## ***Pierre Auger Observatory***

# **Surface Detector Electronics Upgrade UUB Pre Prototype Production Report**

*UUB Model version:* SDE-002-002-IE00

<i>Document written by:</i> E. Lagorio	<i>verified by:</i> P. Stassi
<i>Institute:</i> LPSC Grenoble	
<i>Date:</i> 24 November 2016	<i>Date:</i> 19 November 2016
<i>ATRIUM Reference:</i> 120770	<i>Project Reference:</i> WP05-LPSC-20D

Figure 4: Valid\_Alim modification in schematic (page 11)

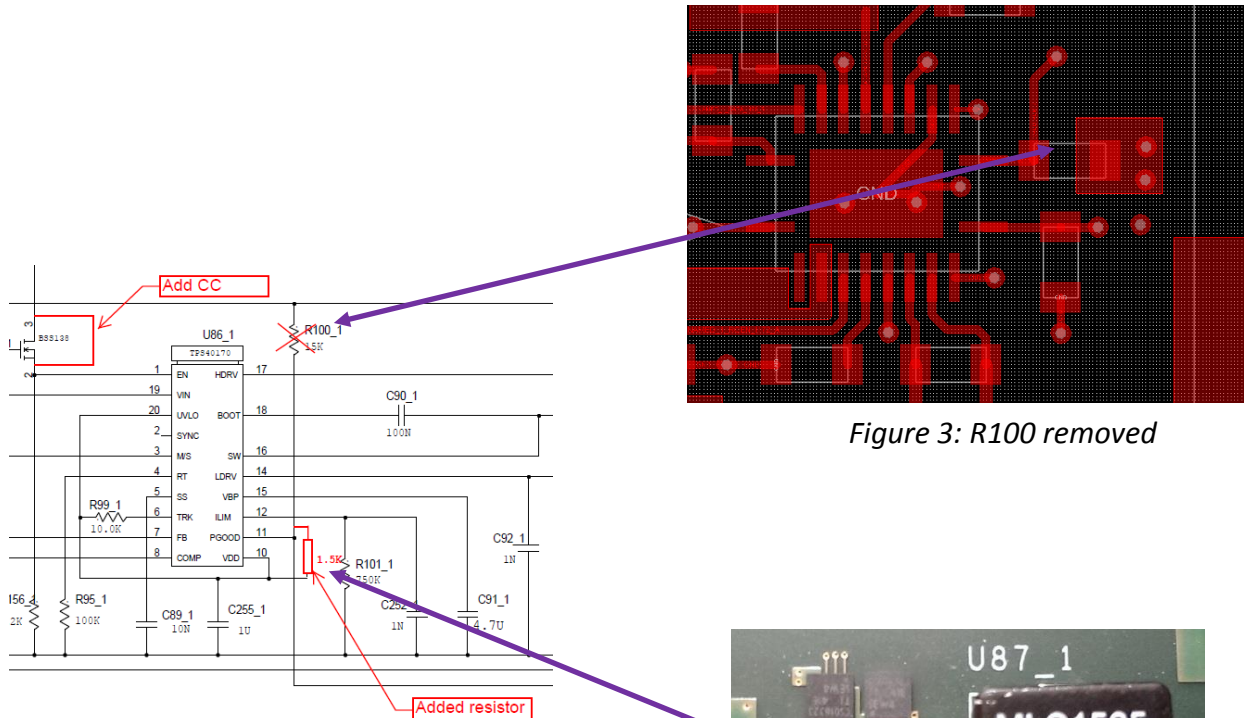
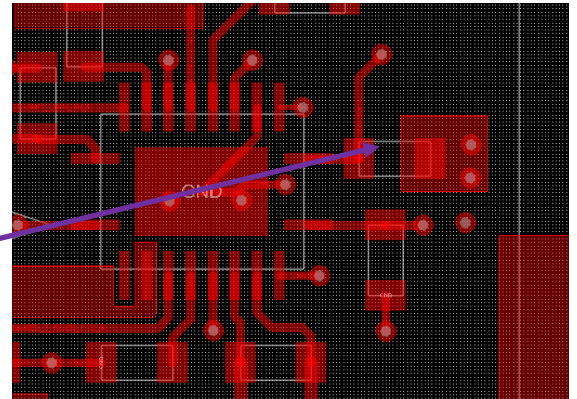
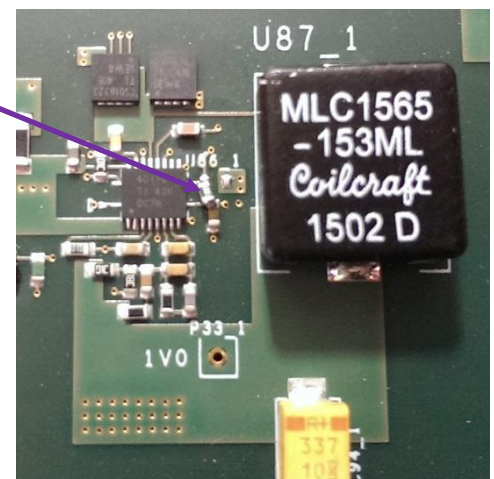
The Valid\_Alim is generated by 1 Volt DC/DC converter, from its “power good” pin.

R100\_1 is removed.

A 1,5 K Ohms 1 % resistor, 0603 package must be added between VDD (U86\_1 pin 10) and PGOOD (U86\_1 pin 11).

Figure 6: Pin 2 &3 Swap connection.

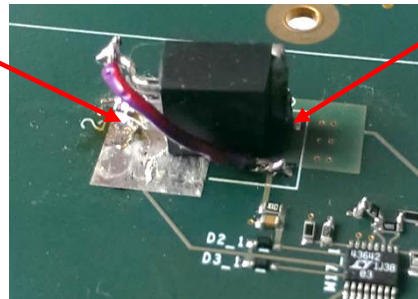
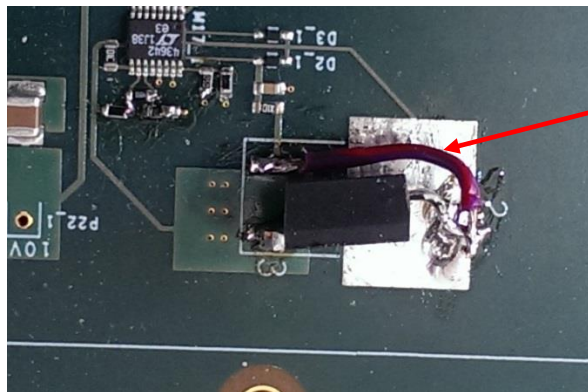
Wrong footprint for Q4\_1 transistor. Pins 2 & 3 must be swapped.

Transistor Pin 3 must be soldered to footprint pin 2

Transistor Pin 2 must be soldered to footprint pin 3

The connection between transistor pin 1 to the footprint must be made by a wire.

Figure 8: DAC7551 Power supply modifications (Schematic page 6).

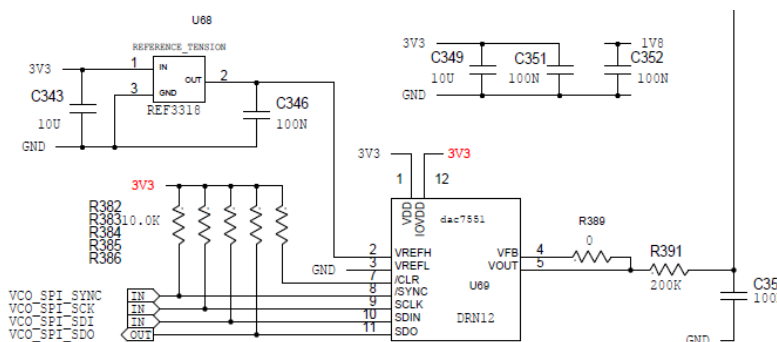
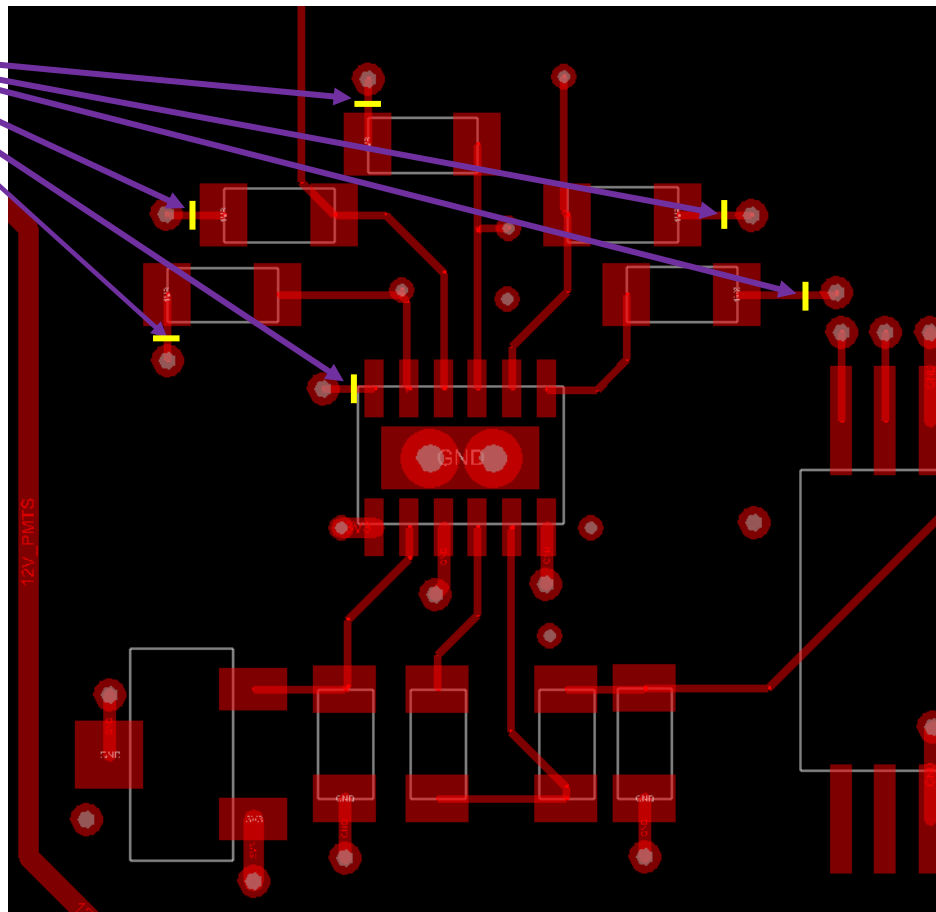
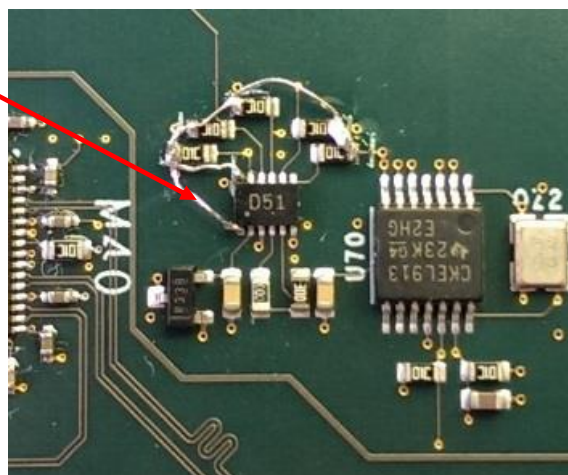
DAC7551 IOVDD pin must be connected to 3,3 Volt (1,8 volt previously) power supply and the pull-up resistors R382, R383, R384, R385 & R386 too.

**3,3 Volts power supply modifications.**  
Add wire between U69 pin 12 and  
resistor R382, R383, R384, R385 & R386

Figure 11: 3,3 Volts wire cut.

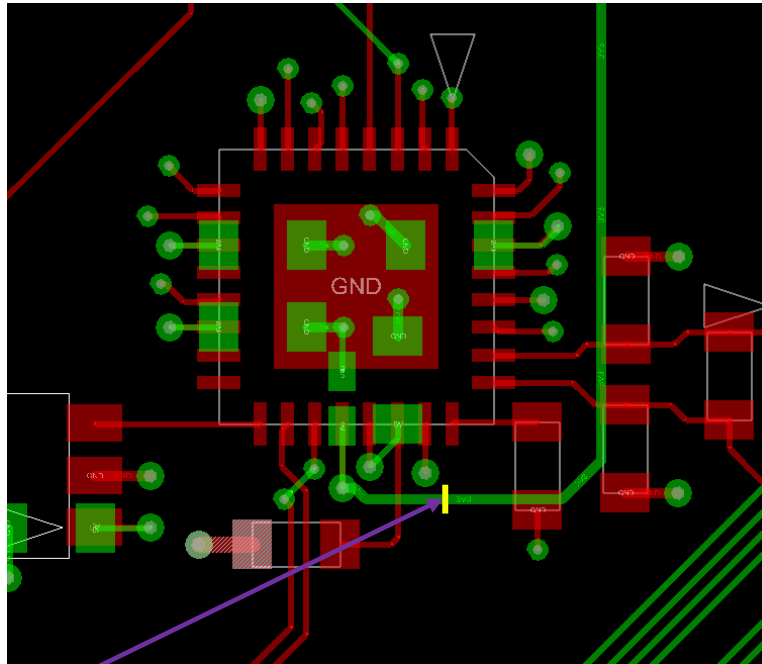
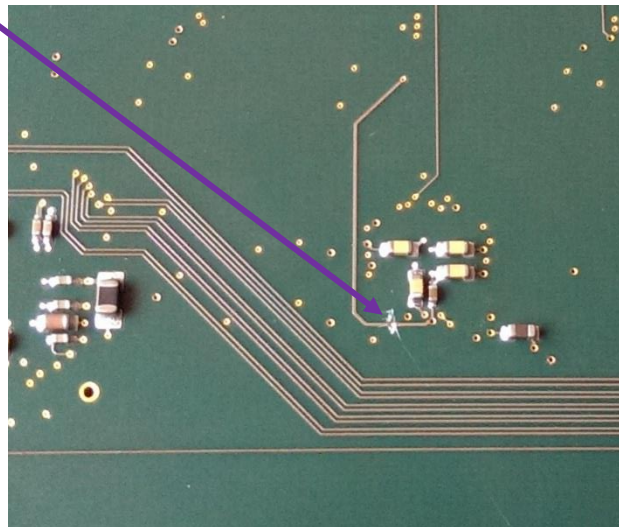
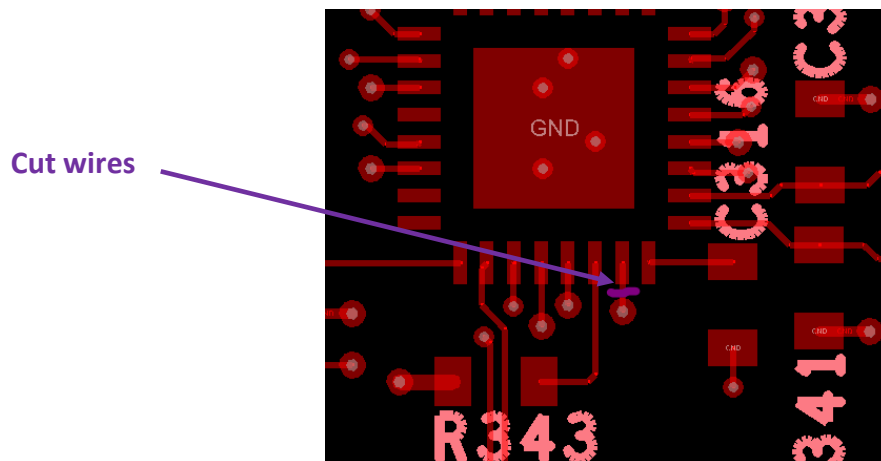
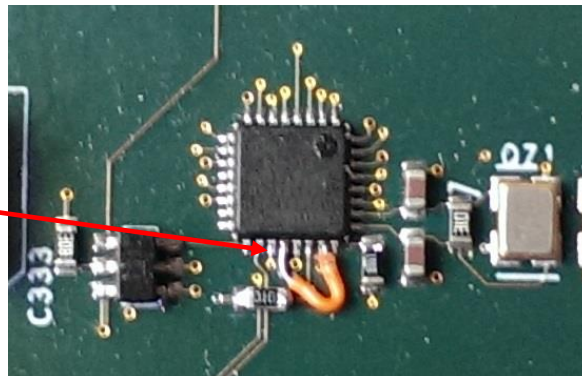
U36 pin 20 must be disconnected from 3,3 Volts and connected to U36 pin 23.

U36 pin 23 must be disconnected from 1,8 Volts and connected to 3,3 Volts.

Figure 15: R343 resistor value changed to 1 kOhms (Schematic page 4).

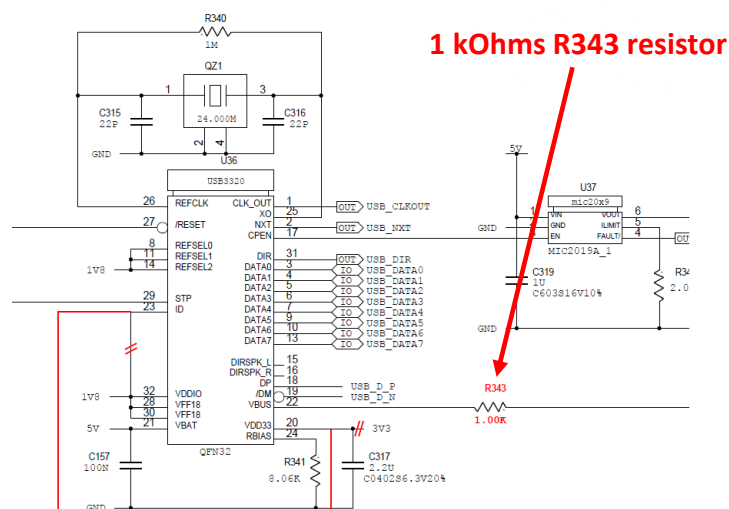
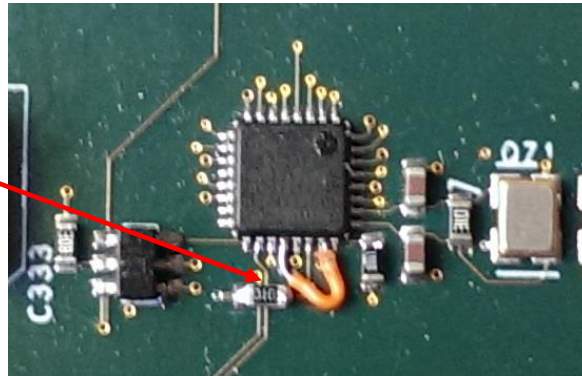
The VBUS R343 resistor value is bad in the Bill Of Material. It must be 1 kOhms instead 10 kOhms (NCR n° 2-43).

Figure 17: Missed FE5 coil (Schematic page 4).

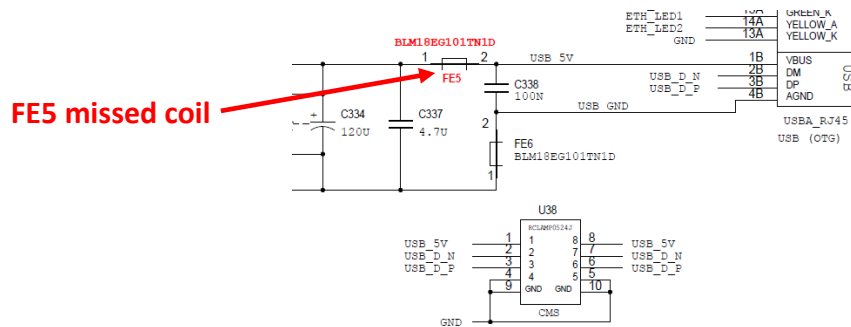
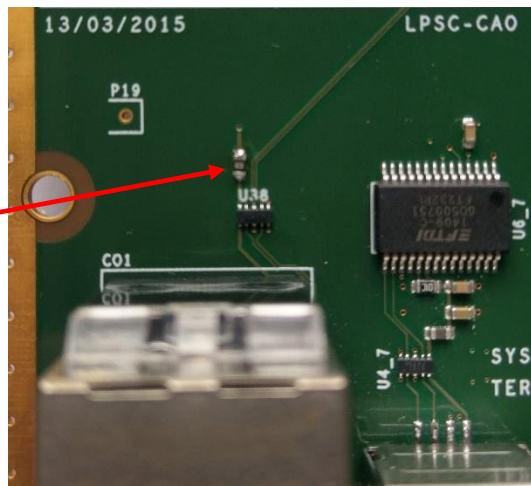
The FE5 coil has been forgotten in the BOM. A 0 Ohm resistor or a short-cut could be put (NCR n° 2-42).

Figure 19: +/- 3,3 Volts Enable modification (Schematic page 10).

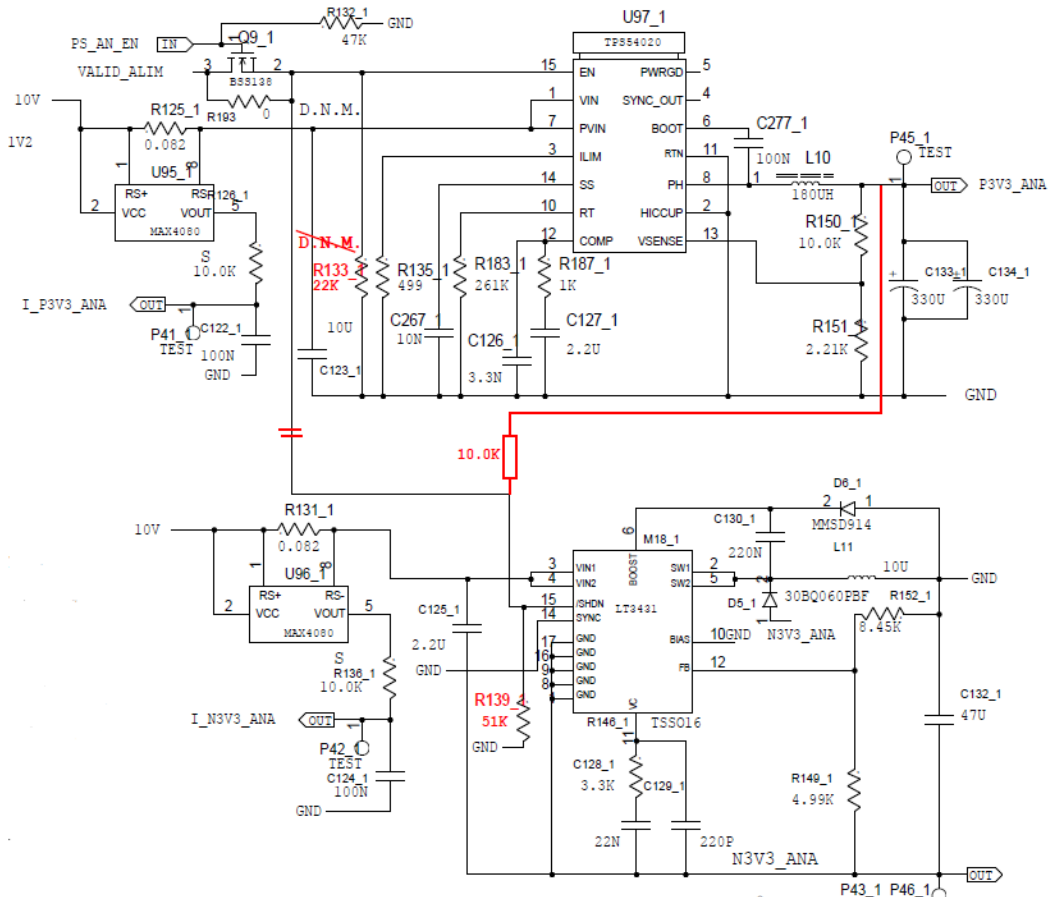
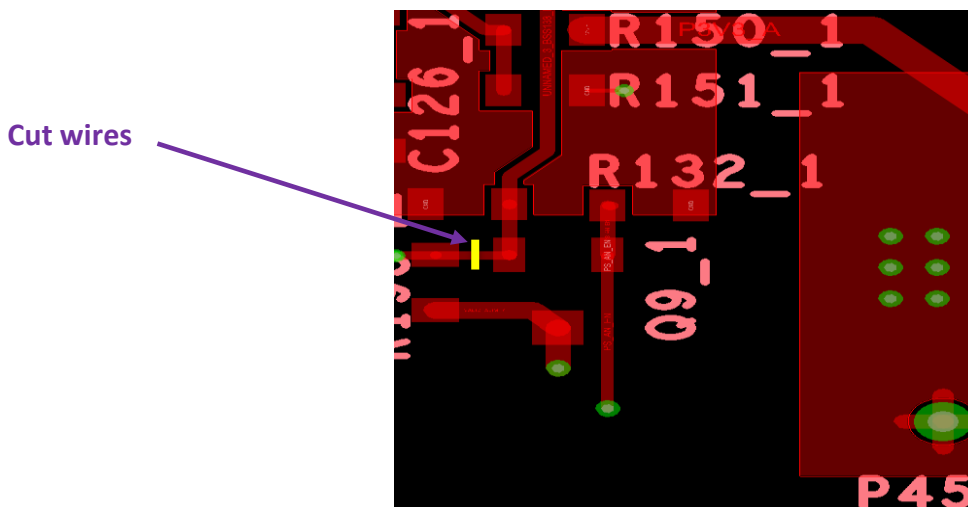
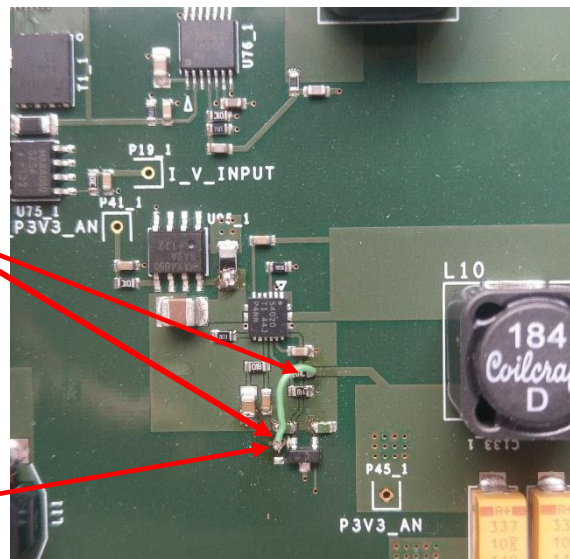
For the SDE-002-002-IE00 UUB board only, the +/- 3,3 Volts Enable will be send from the Slow-Control micro-controller (3,3Volts) to U97\_1 +3,3V DC/DC pin15 (EN) and U18\_1 -3,3V DC/DC pin 15 (/SHDN). The +3,3V DC/DC output will enable the -3,3V DC/DC enable.

Add a wire from the added  
10 kOhms resistor to  
+3,3 Volts on R150\_1 pin

Add 10 kOhms resistor

Figure 22: BOTTOM side R139\_1 resistor value modification.

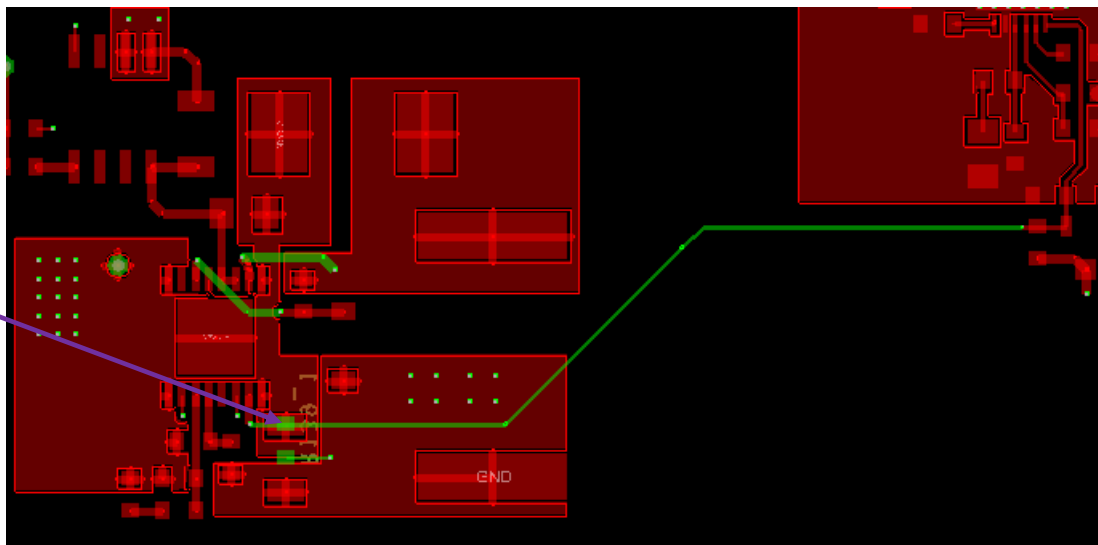
R139\_1 resistor value must be changed from 22 kOhms to 51 kOhms.

Figure 23: FPGA boot configuration jumper (Schematic page 23).

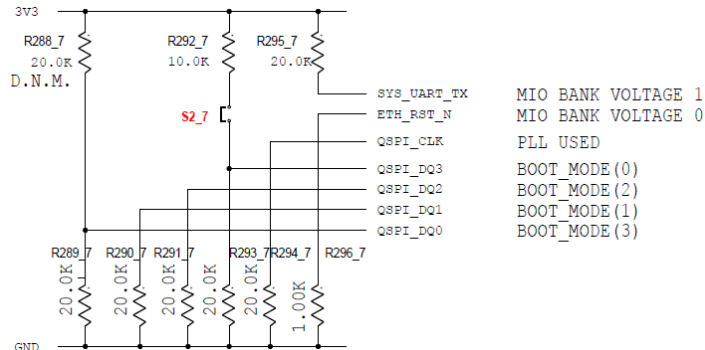
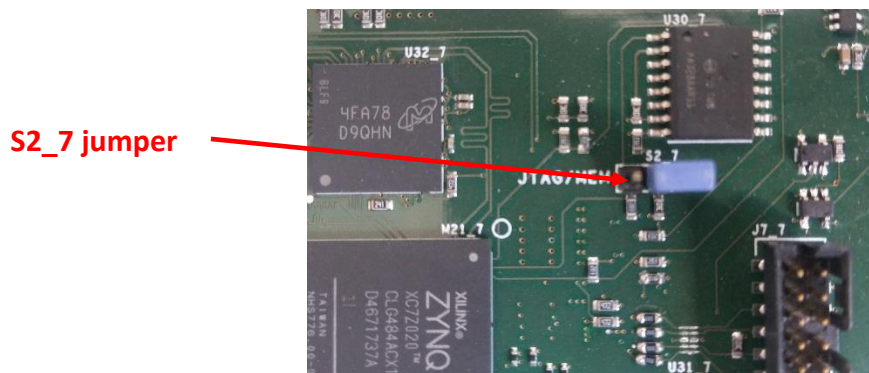
The boot configuration jumper (S2\_7) has been forgotten in the Bill Of Material (NCR n° 2-1). It must be added.

Figure 25: GPS antenna configuration resistor (Schematic page 3).

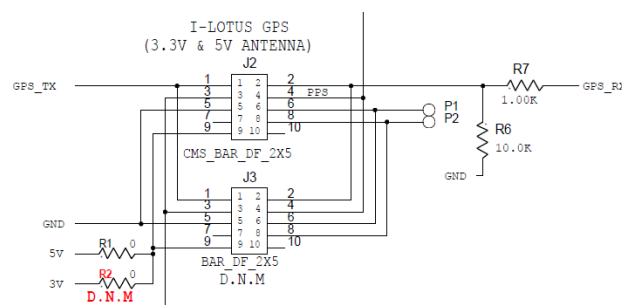
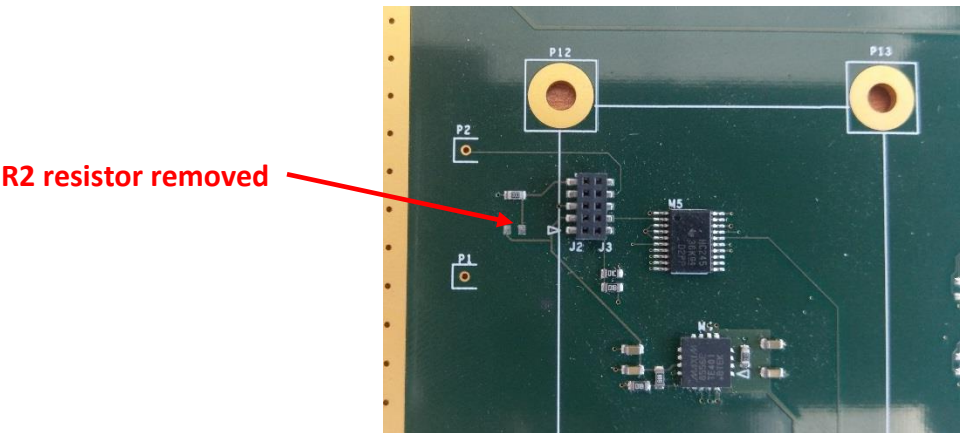
The GPS antenna could be powered by 2 types of voltages, 3 Volts or 5 Volts. On the board this choice is made by R1 and R2 0 Ohm resistors. Presently, the 2 resistors are soldered on board (NCR n° 2-2). R2 resistor must be removed.

Figure 27: Slow-Control RESET configuration resistors (Schematic page 12).

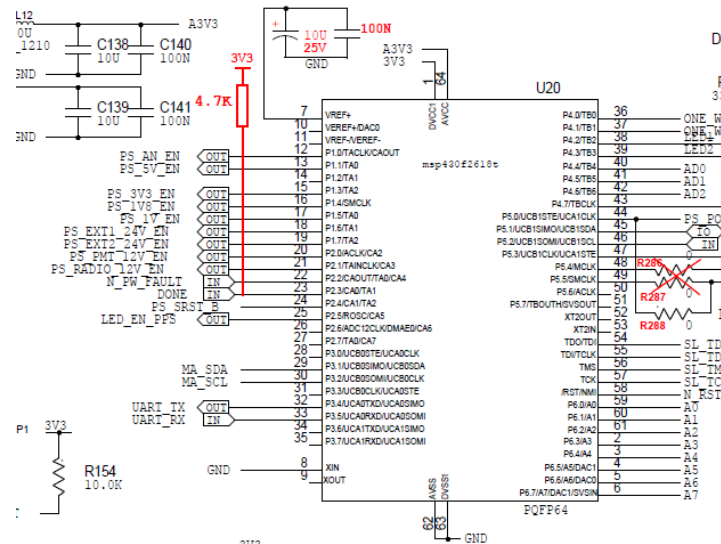
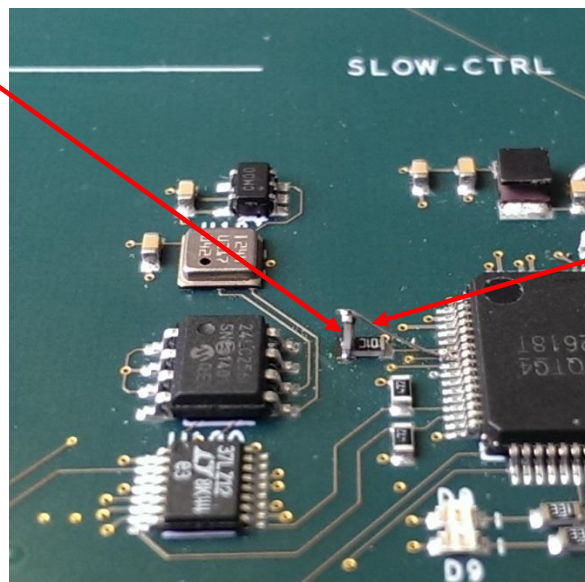
4,7 kOhms 1% and 0603 package Pull-up resistor must be added between 3V3\_SLOW\_CTRL and U20 pin 23 (schematic page 12).

Figure 29: Vref decoupling capacitors.

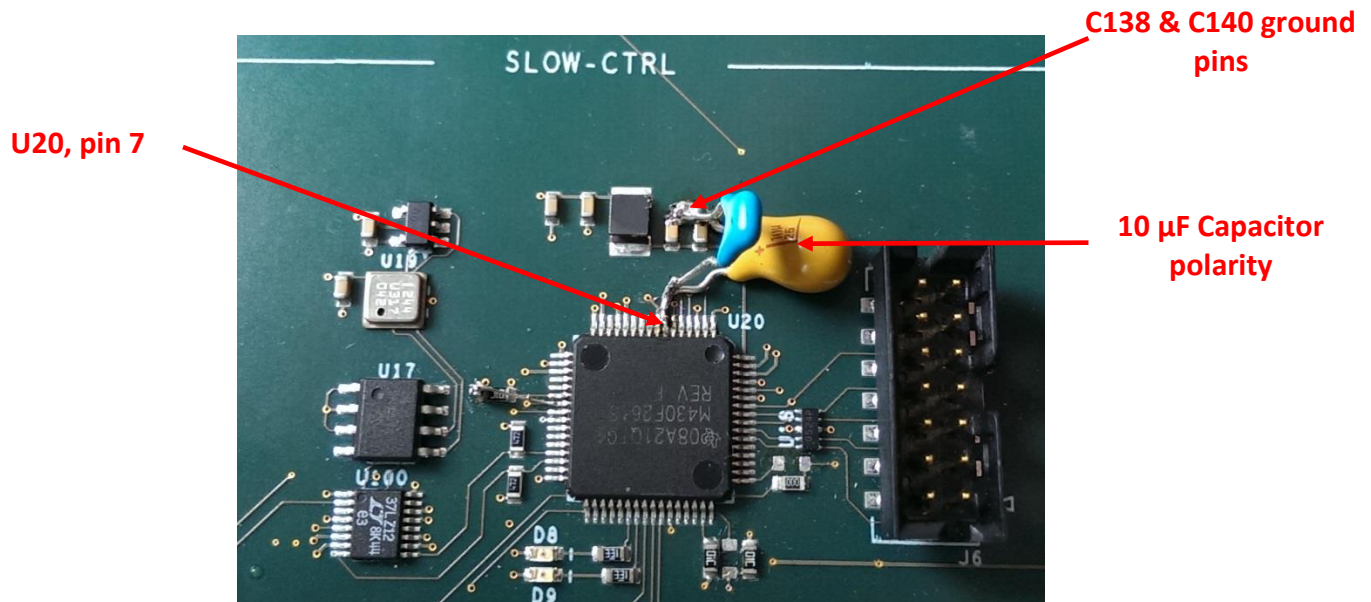
Connect 10  $\mu\text{F}$  25 Volts and 100nF capacitors in parallel to U20 pin 7 and C138 & C140 ground pins.

Be careful to 10 $\mu\text{F}$  polarity connected to U20 pin 7.
